16 October 2007

**RE: SOUTHERN EMPLOYMENT LANDS**

Boral proposes to modify Major Project No 06\_0181 for the Greystanes Southern Employment Lands.

**OPTION 3 - 5ML STORAGE**

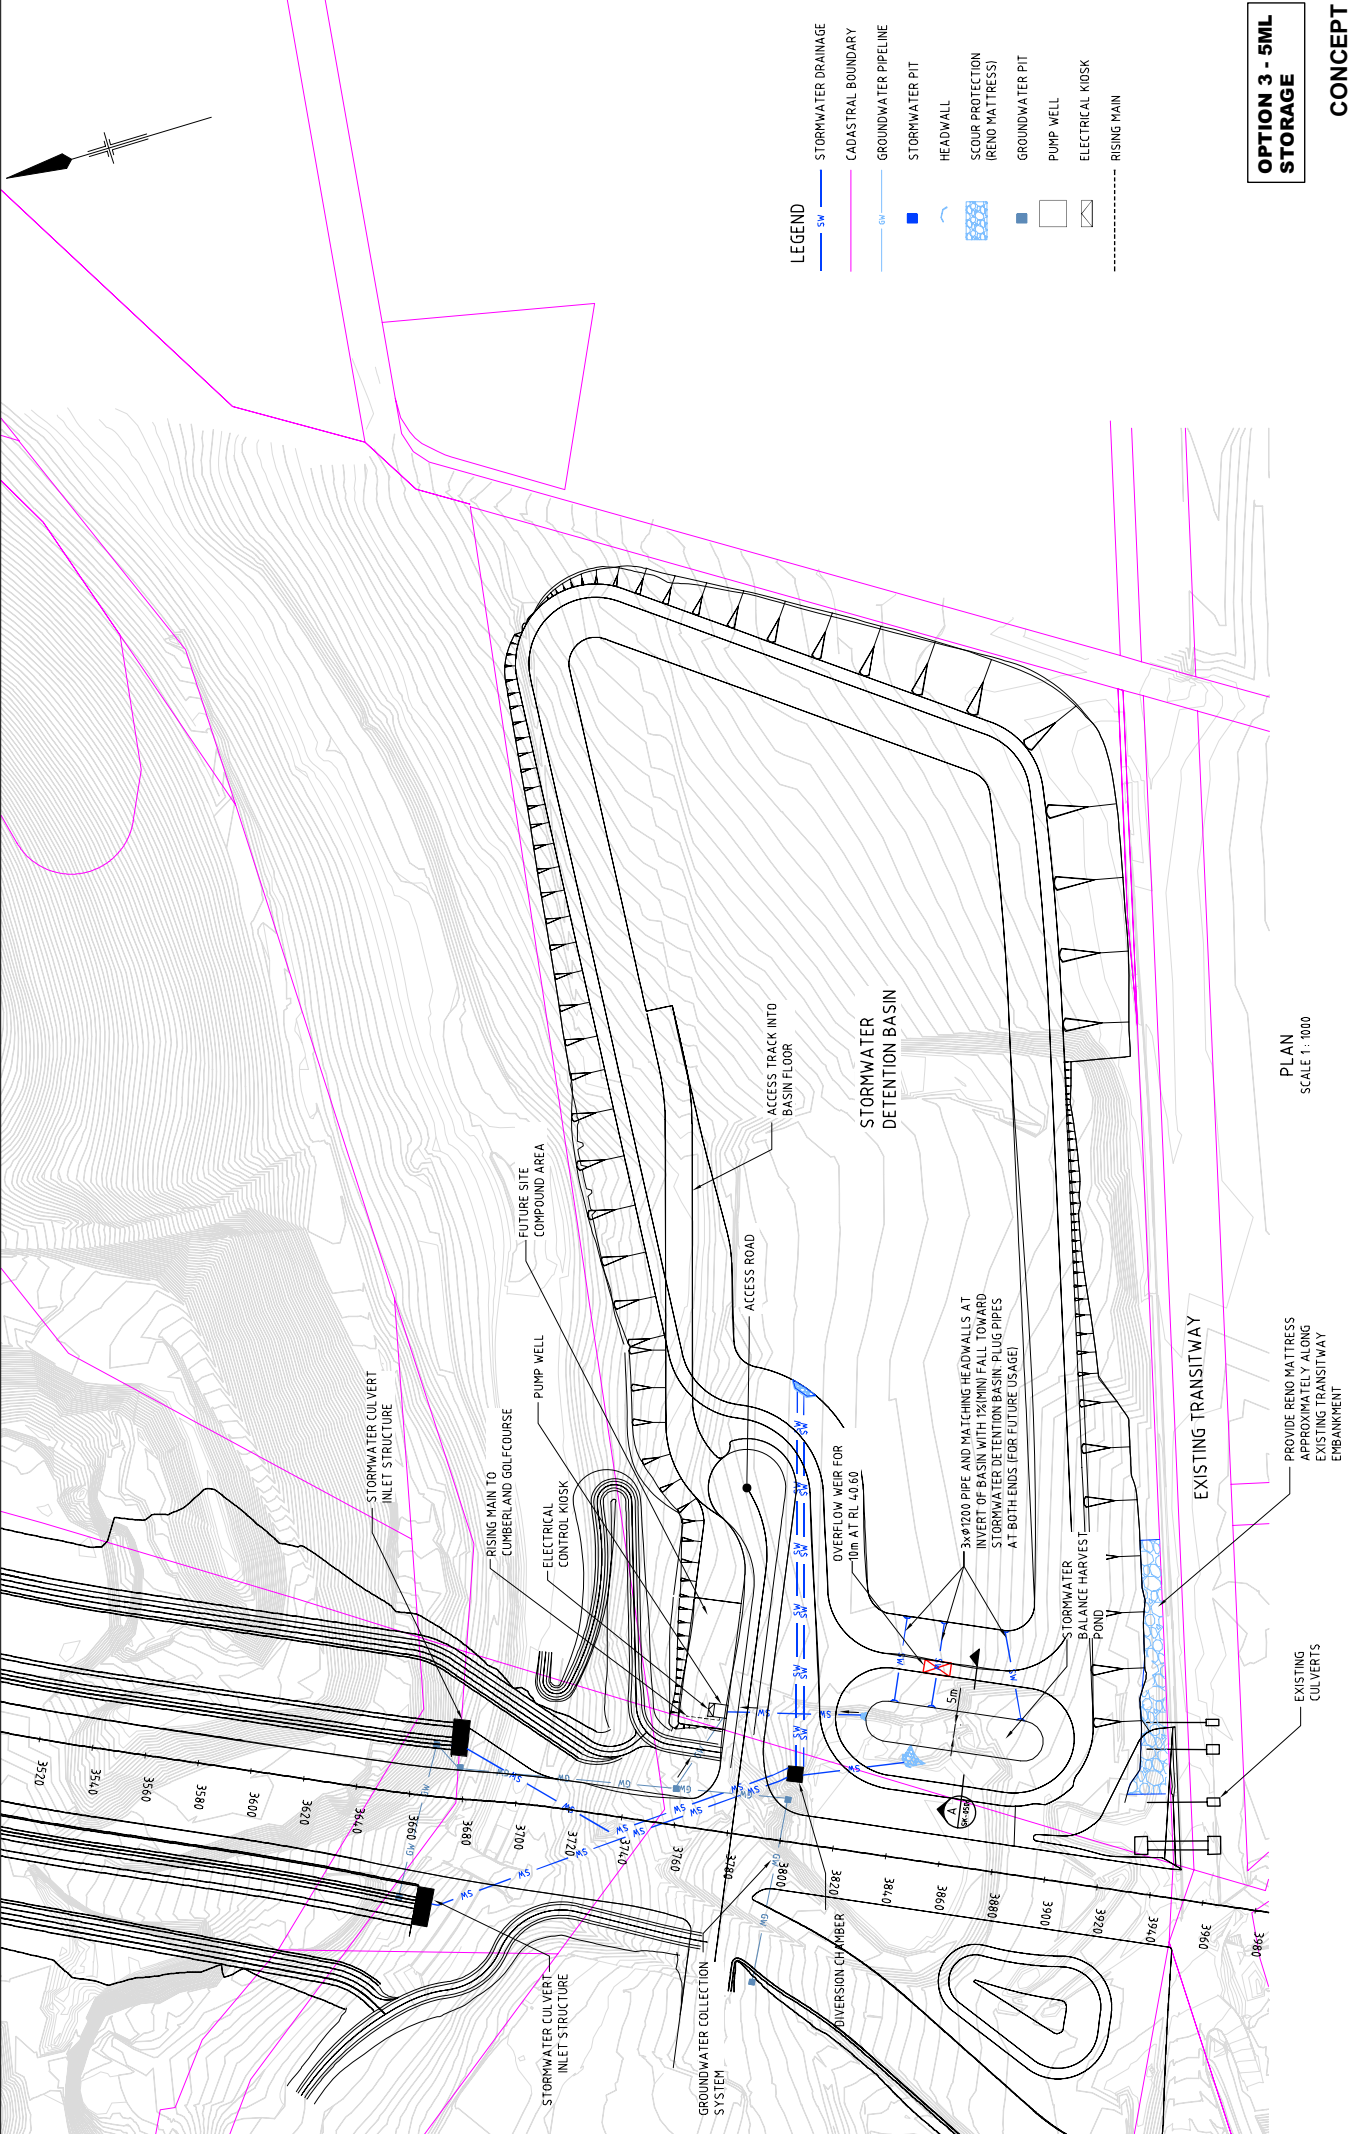
- a detention basin at Widemere East with a storage volume of approximately 202,255 cubic metres of storage capacity covering an area of 11.1Ha; and
- a 5 Mega litre storage dam/harvesting pond that collects and stores the peak 3 month low stormwater flows as a minimum for the site for pumping to the Cumberland County Golf Club for purposes;

**BORAL RECYCLING PTY. LTD.**  
**GREYSTANES ESTATE SEL**  
**WIDEMERE EAST**  
**CCGC PUMP STATION CONCEPT LAYOUT**

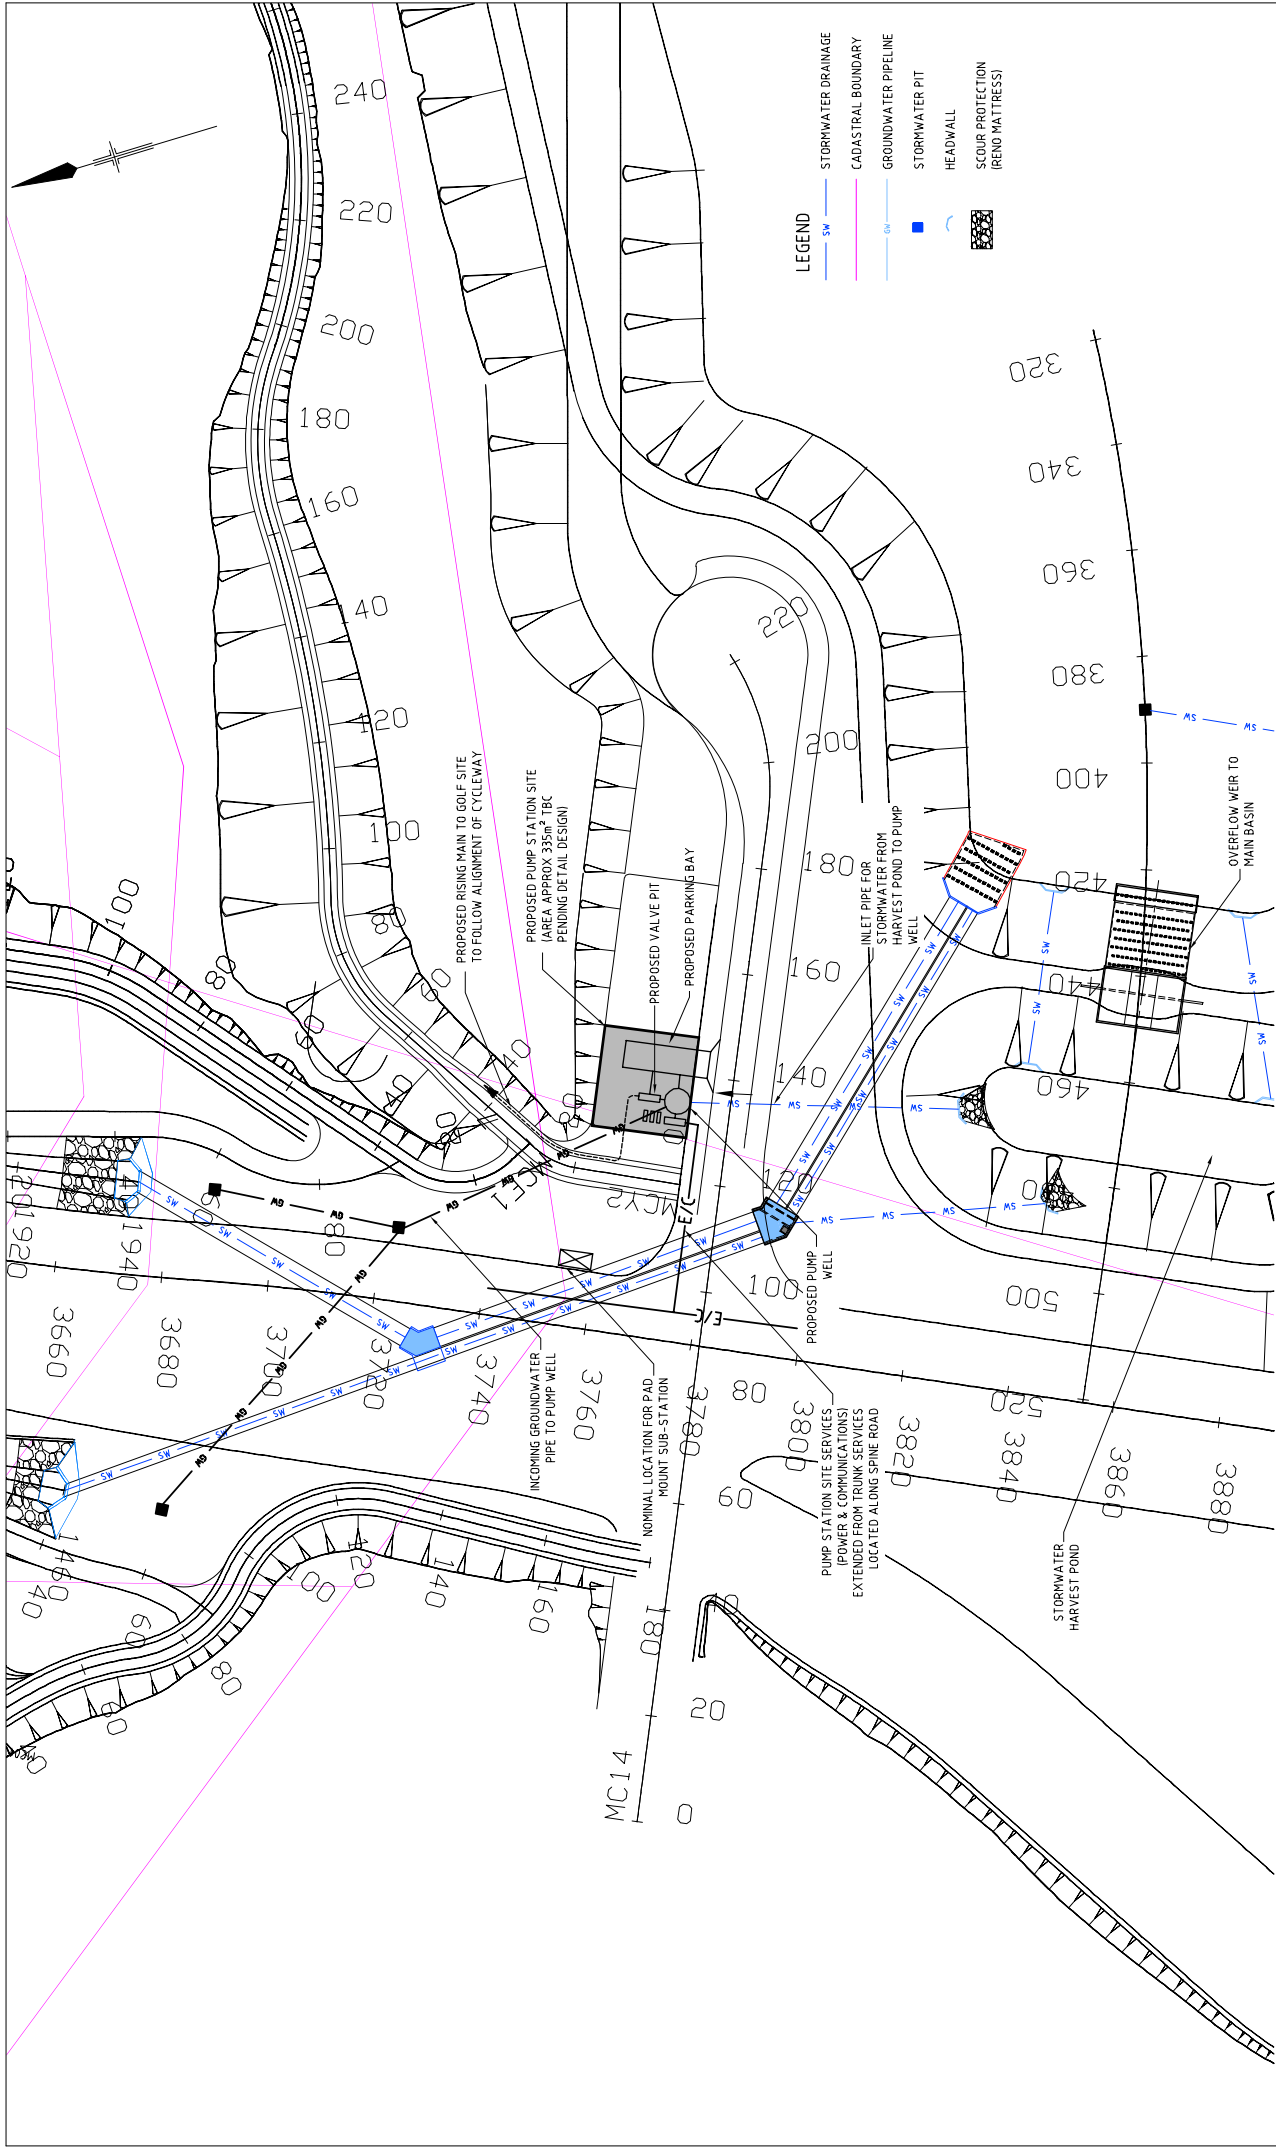
- o the collection of groundwater at a pump well and a pumping station in Widemere East for pumping to the Cumberland County Golf Club for re-use purposes. A concept layout for the pumping station is illustrated on plans in *Annex A*. The treatment of groundwater shall be undertaken at the Cumberland County Golf Club as and if necessary for intended re-use purpose; and

# CONCEPT MASTERPLAN

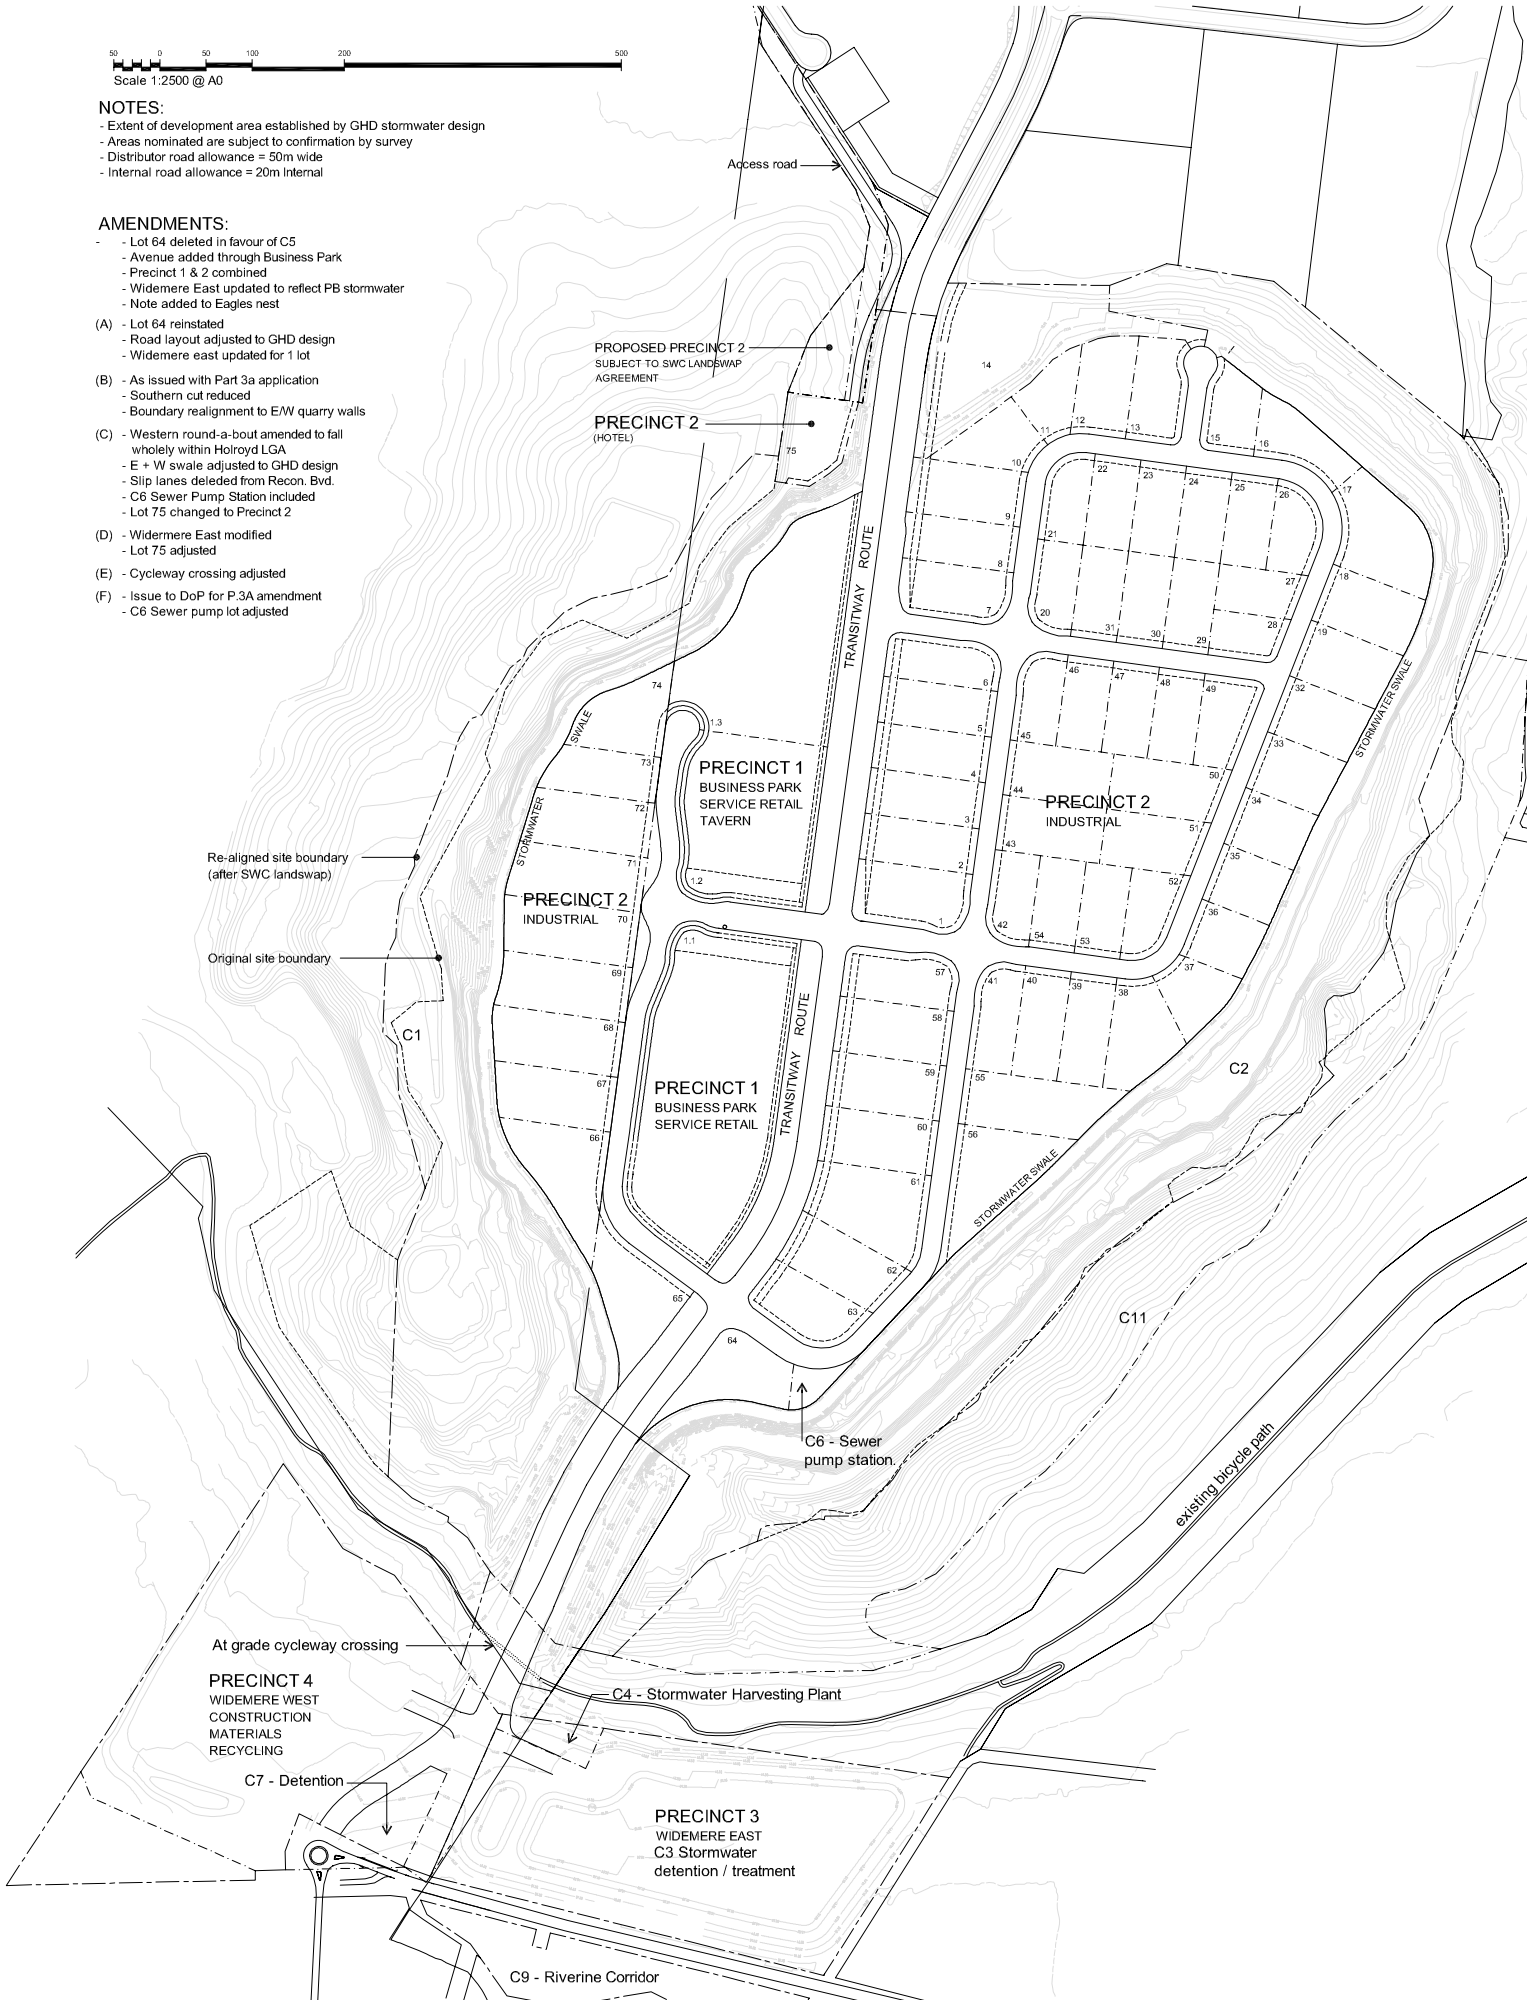
- Lot 64 deleted in favour of C5
- Avenue added through Business Park
- Precinct 1 & 2 combined
- Widemere East updated to reflect PB stormwater
- Note added to Eagles nest
- (A) - Lot 64 reinstated
- Road layout adjusted to GHD design
- Widemere east updated for 1 lot
- (B) - As issued with Part 3a application
- Southern cut reduced
- Boundary realignment to EMW quarry walls
- (C) - Western round-a-bout amended to fall wholly within Holroyd LGA
- E + W swale adjusted to GHD design
- Slip lanes deleted from Recon. Blvd.
- C6 Sewer Pump Station included
- Lot 75 changed to Precinct 2
- (D) - Widemere East modified
- Lot 75 adjusted
- (E) - Cycleway crossing adjusted
- (F) - Issue to DoP for P.3A amendment
- C6 Sewer pump lot adjusted
